Re: Rosemont Copper Mitigation Preferences

PIMA COUNTY DISCUSSION ITEMS

ATTACHMENT 1

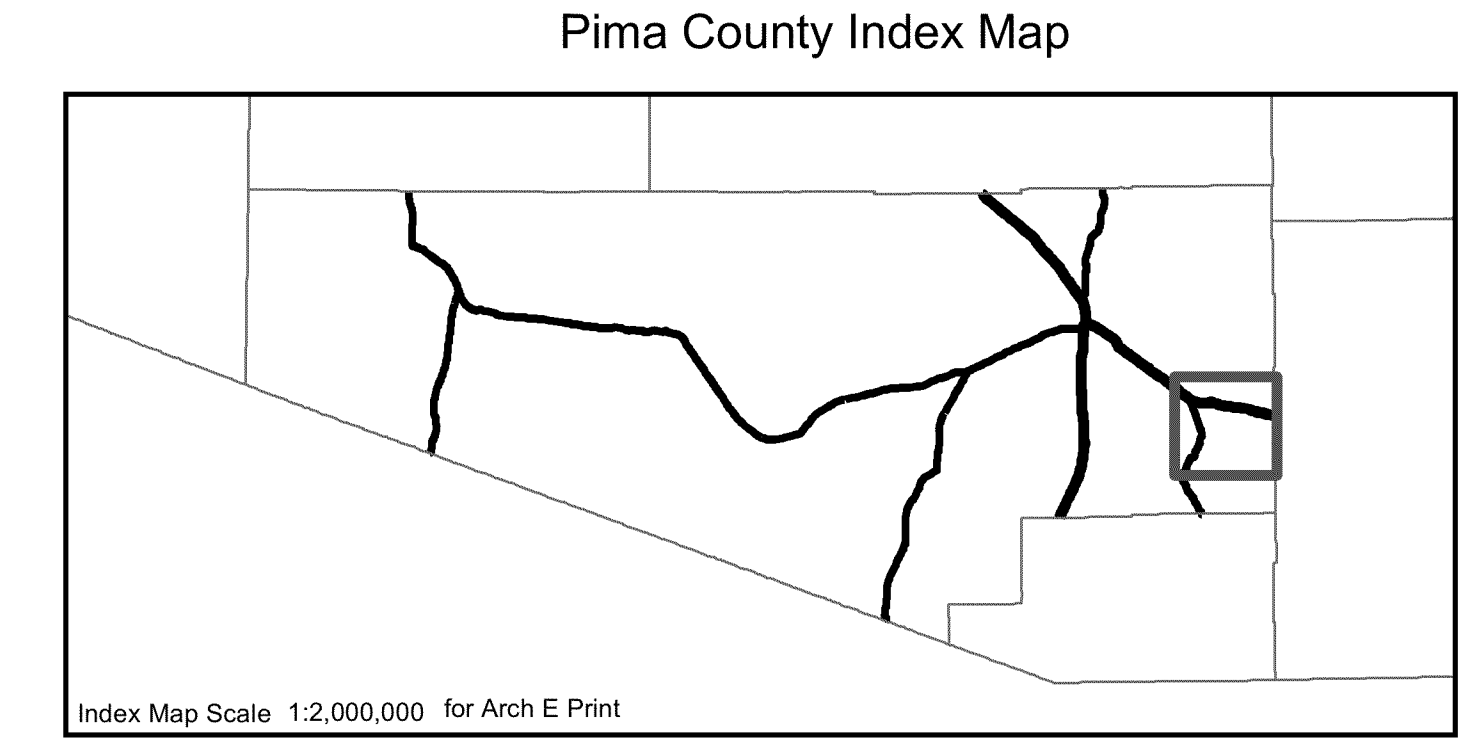
Because Rosemont may need to provide additional federal mitigation requirements, the potential State Trust acquisitions have been divided into four groupings, each of which provides different benefits to consider. I attempted to exclude well-known mines and mineral deposits from the selections.

Attachment 1 shows each of the priority mitigation areas and their relationship or adjacency to existing conservation efforts of the County.

Davidson Canyon Additions

The Davidson Canyon additions are in an area of indirect effects of the mine. They are accessible to the public and include areas that would be vulnerable to future commercial or residential development. The additions include most of the Important Riparian Area along Davidson Canyon, as well as area identified as Biological Core in the Conservation Lands System (CLS). Long-term protection of these lands would maintain an important wildlife linkage to the Preserve and to some private lands that Rosemont has already acquired for mitigation, in addition to closing the "gap" between the Preserve and the portion of the Bar V Ranch that lies within Davidson Canyon. The land selection does not include the proposed limestone mine on Davidson Canyon. The southernmost portions of the addition include designated Critical Habitat for the jaguar.

Lower Cienega Creek Additions

These lands north of the interstate highway buffer the Preserve from existing and proposed future developments, including groundwater development. Much of the area is currently accessible to the public via existing trails or roads. North of Interstate 10, the additions are primarily uplands located in Biological Core but include a few small areas of riparian vegetation. These lands also include an area that would help maintain connectivity to the Rincon Mountains via the adjacent Mackenzie property. South of the interstate, the

selections include Important Riparian Areas along the main stem of Cienega Creek itself and areas of adjacent Biological Core. These land selections would connect the Preserve to Las Cienegas National Conservation Area (NCA), and the portion just downstream of the NCA is considered Critical Habitat for the jaguar. Most of these lands are far from the mine and less affected than the Davidson Canyon Additions.

Santa Rita Linkage Additions

The main purpose of this land selection is to maintain connectivity for wildlife between the northern end of the Santa Rita Mountains and Davidson Canyon and to protect areas identified as Biological Core. This land selection also includes an intermittent stock tank that has in the past harbored invasive crayfish. The stock tank and contributing wash could be managed for more natural aquatic resource functions. A perennial lake (the Lake) that has been used as a public recreation area has previously been stocked with sportfish by the Arizona Game and Fish Department. The lake is located within designated Critical Habitat for the jaguar. These lands are close to the mine; and, therefore, their preservation could reduce or compensate for some of the mine's indirect impacts on recreation, land use and wildlife movement.

Whetstone Riparian Additions

The main purpose of this land selection is to protect Important Riparian Area along Wakefield Canyon and to maintain connectivity for wildlife between the Whetstone Mountains and areas to the north and east. The land selection includes areas of intermittent stream flow, springs, associated riparian vegetation and areas of Biological Core. Most of the area is within designated Critical Habitat for the jaguar and may contain suitable habitat for ocelot and yellow-billed cuckoo. The acquisitions would join the County's Empirita Ranch acquisition with adjacent federal lands. The land also includes a historically significant ranch structure. Of the four groupings, these lands are the most remote and least affected by the mine proposal.

Our priority would first be the Lower Cienega Creek acquisition of 4,885 acres, followed by Davidson Canyon at 2,739 acres; then the Santa Rita linkage, followed by the Whetstone Riparian Additions.

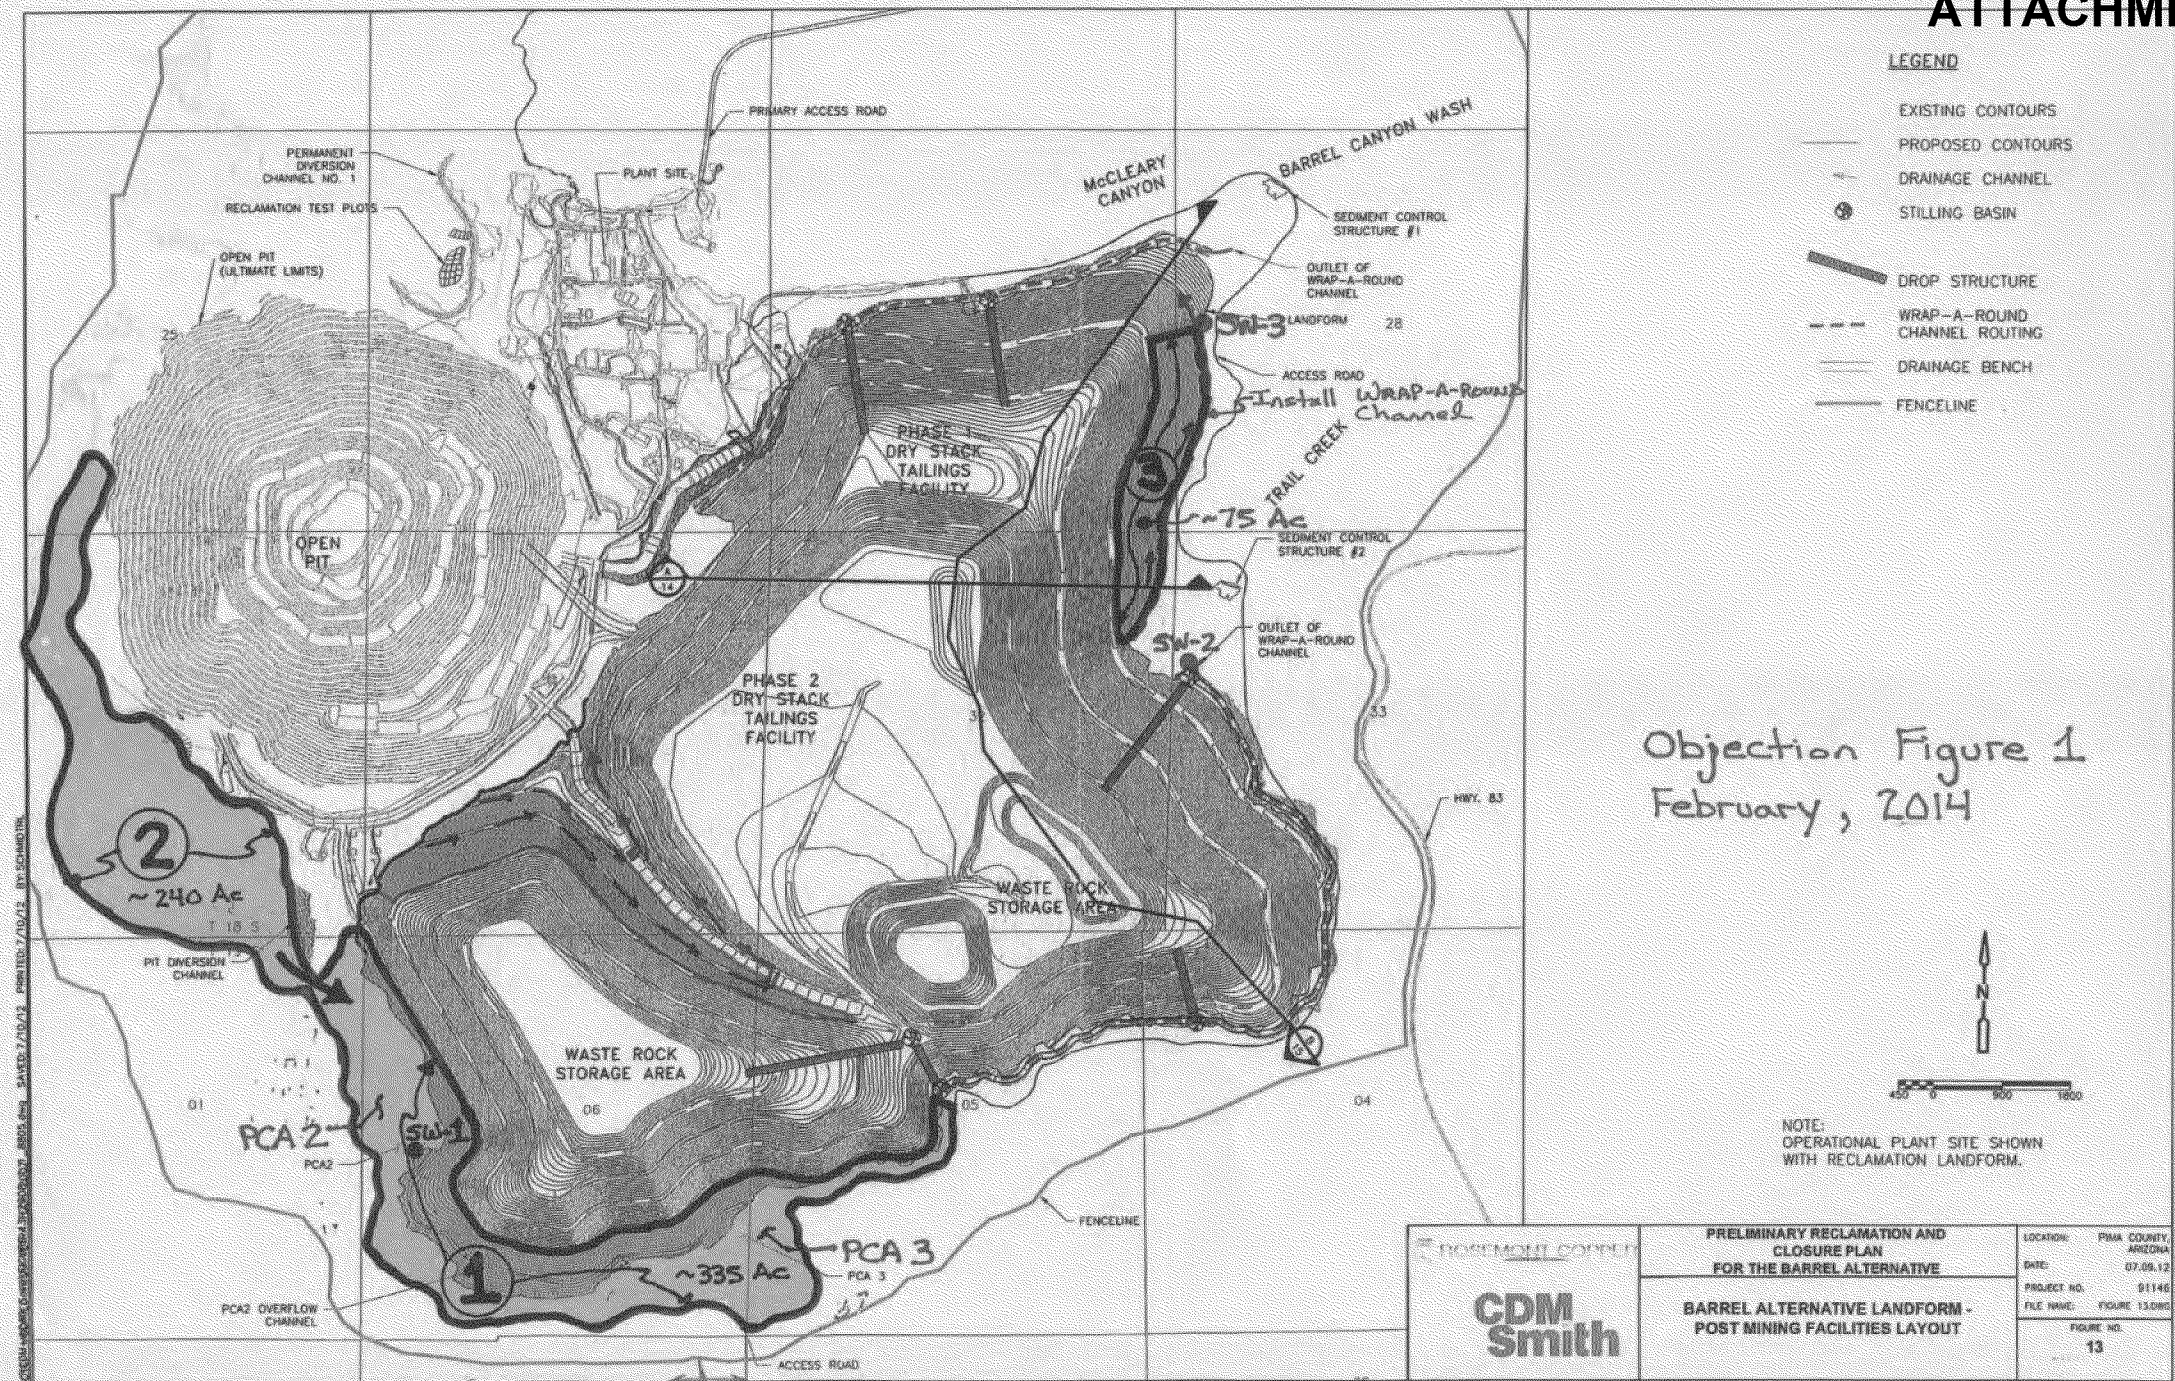
10. Release surface water into Trail Canyon from western and southern portion of the mine site, and allow runoff from northeastern tailings mound into Barrel Canyon (Mark) Modify the site water management plan to reduce impacts.

13. FEIS fails to disclosure impacts to Coleman's coralroot. (Brian) Barrel Alternative was chosen, in part, to avoid a population of Coleman's corralroot, but the company is proposing to divert water above the largest known population of this plant (representing 40% of all known individuals). Discuss in EIS.
